**Economic Commission for Europe****Inland Transport Committee****World Forum for Harmonization of Vehicle Regulations****Sixty-first session**

**Regulation No. 129 (Enhanced Child Restraint Systems)****Proposal for Supplement 2 to the 02 series of amendments to Regulation No. 129****Submitted by the expert from France\***

Figure 1.

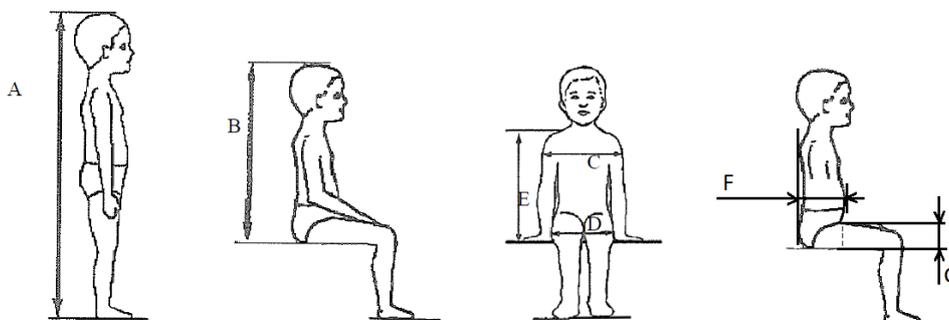
*Annex 18*, amend to read:

## "Annex 18

### **Geometrical dimensions of Enhanced Child Restraint Systems**

<i>Min.</i>	<i>Min.</i>	<i>Min.</i>	<i>Min.</i>	<i>Max</i>	<i>Min.</i>	<i>Max</i>		<i>Minimum</i>	<i>Minimum</i>
<i>Stature</i>	<i>Sitting height cm</i>	<i>Shoulder breadth cm</i>	<i>Hip breadth cm</i>	<i>Shoulder height cm</i>	<i>Shoulder height cm</i>	<i>Abdomen depth cm</i>	<i>Abdomen depth cm</i>		<i>Upper leg thickness cm</i>	<i>Upper leg thickness cm</i>
A	B	C	D	E1	E2	F1	F2		G1	G2
	95%ile	95%ile	95%ile	5%ile	95%ile	5%ile	95%ile		5%ile	95%ile
40	NA	NA	NA	NA	NA	NA	NA		NA	NA
45	39.0	12.1	14.2	27.4	29.0	NA	NA		NA	NA
50	40.5	14.1	14.8	27.6	29.2	NA	NA		NA	NA
55	42.0	16.1	15.4	27.8	29.4	NA	NA		NA	NA
60	43.5	18.1	16.0	28.0	29.6	NA	NA		NA	NA
65	45.0	20.1	17.2	28.2	29.8	NA	NA		NA	NA
70	47.1	22.1	18.4	28.3	30.0	NA	NA		NA	NA
75	49.2	24.1	19.6	28.4	31.3	<b>12,5</b>	<b>15,1</b>		<b>5,7</b>	<b>8,4</b>
80	51.3	26.1	20.8	29.2	32.6	<b>12,7</b>	<b>15,7</b>		<b>5,8</b>	<b>8,4</b>
85	53.4	26.9	22.0	30.0	33.9	<b>12,9</b>	<b>16,2</b>		<b>5,9</b>	<b>8,5</b>

90	55.5	27.7	22.5	30.8	35.2	<b>13,1</b>	<b>16,8</b>		<b>6,2</b>	<b>8,5</b>
95	57.6	28.5	23.0	31.6	36.5	<b>13,3</b>	<b>17,8</b>		<b>6,5</b>	<b>8,9</b>
100	59.7	29.3	23.5	32.4	37.8	<b>13,5</b>	<b>18,2</b>		<b>6,5</b>	<b>9,6</b>
105	61.8	30.1	24.9	33.2	39.1	<b>13,6</b>	<b>18,8</b>		<b>6,6</b>	<b>10,3</b>
110	63.9	30.9	26.3	34.0	40.4	<b>13,9</b>	<b>19,6</b>		<b>6,6</b>	<b>10,3</b>
115	66.0	32.1	27.7	35.5	41.7	<b>13,9</b>	<b>19,9</b>		<b>6,6</b>	<b>10,4</b>
120	68.1	33.3	29.1	37.0	43.0	<b>14,3</b>	<b>20,2</b>		<b>6,8</b>	<b>10,5</b>
125	70.2	33.3	29.1	38.5	44.3	<b>14,7</b>	<b>20,7</b>		<b>7,5</b>	<b>10,9</b>
130	72.3	33.3	29.1	40.0	46.1	NA	NA		NA	NA
135	74.4	33.3	29.1	41.5	47.9	NA	NA		NA	NA
140	76.5	34.2	29.6	43.0	49.7	NA	NA		NA	NA
145	78.6	35.3	30.8	44.5	51.5	NA	NA		NA	NA
150	81.1	36.4	32.0	46.3	53.3	NA	NA		NA	NA
